Docket Item # 9
BAR CASE # 2008-0115

BAR Meeting
September 17, 2008

ISSUE: Concept for an Addition and Alterations

LOCATION: 532 N. Washington Street

Figure 3. Proposed demolition for east and west elevations.

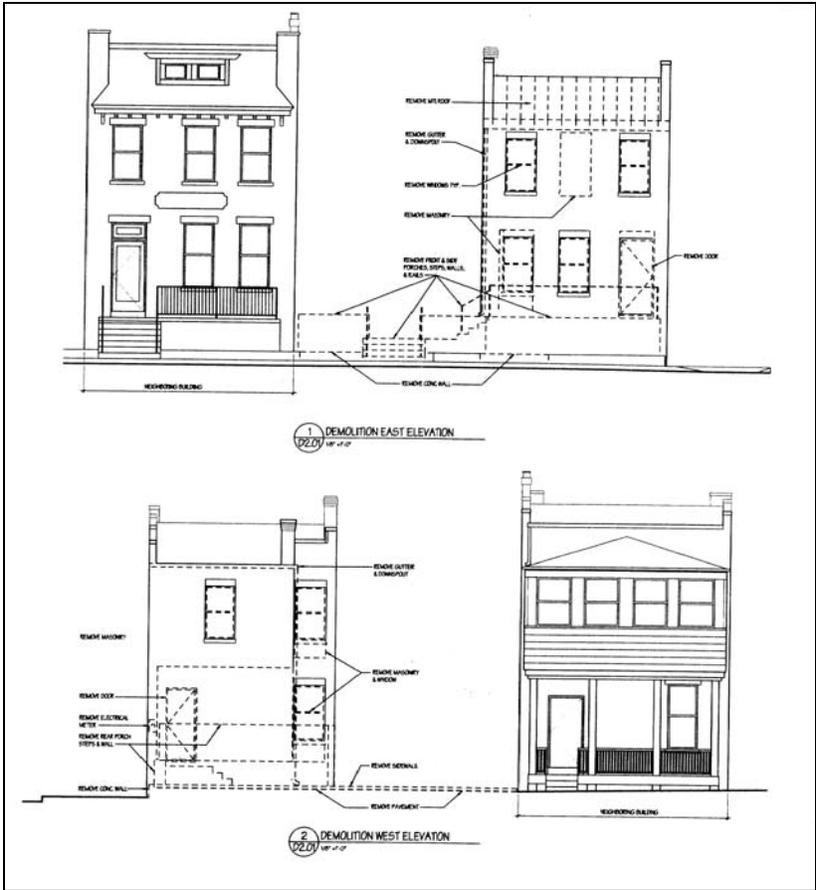
Staff finds that the removal of portions of the historic fabric to accommodate new window and door openings to be acceptable as the historic integrity of the building will remain. On this elevation, the applicant will remove a portion of the masonry wall on the second story to accommodate a new window opening as well as a portion of masonry to move the door on the first story. Staff finds the proposed alterations acceptable and compatible with the architectural style of this building. Staff notes that the front façade features long, highly-textured brick with deeply recessed mortar joints. Staff urges the applicant to retain and reuse this brick when filling in a portion of the existing door opening which will be converted to a window.

Figure 5. Proposed site plan.

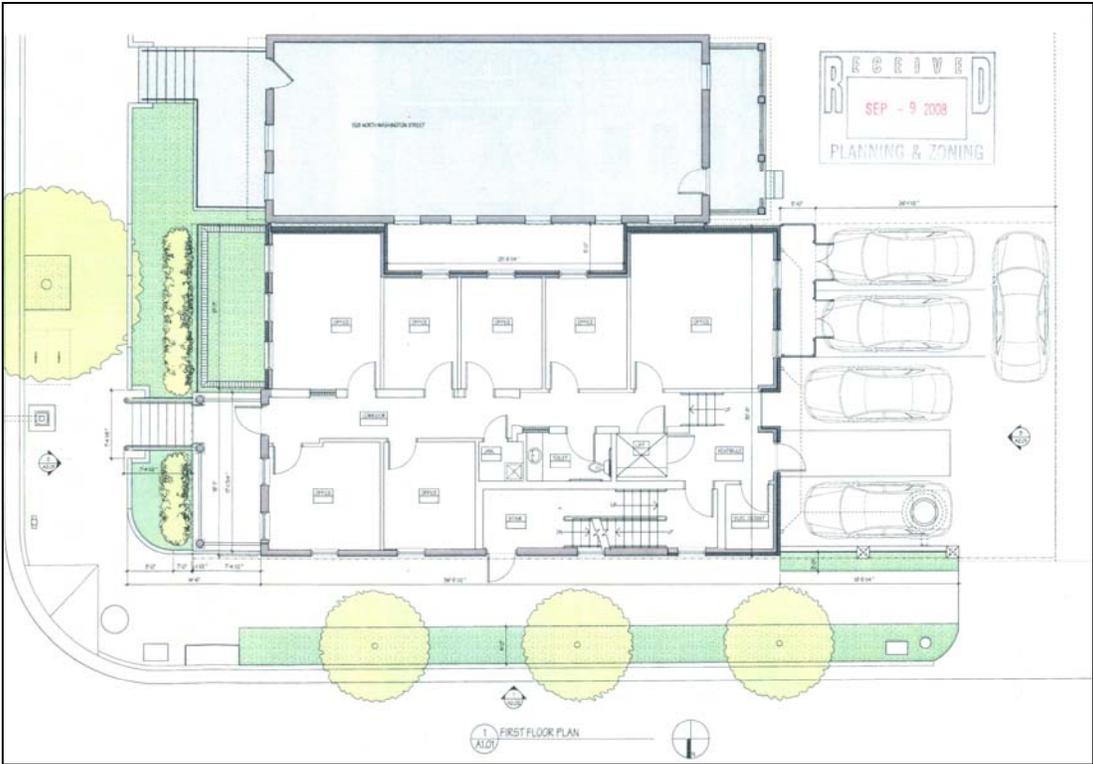
Staff has no objection to the proposed wood and masonry fence. Staff recommends that the proposed fence be no more than 6 feet in height and that the wood portion be stained or painted.

3. That the wood portion of the proposed fence be stained or painted.
4. That the applicant work with Staff in determining appropriate specifications for details related to the addition.
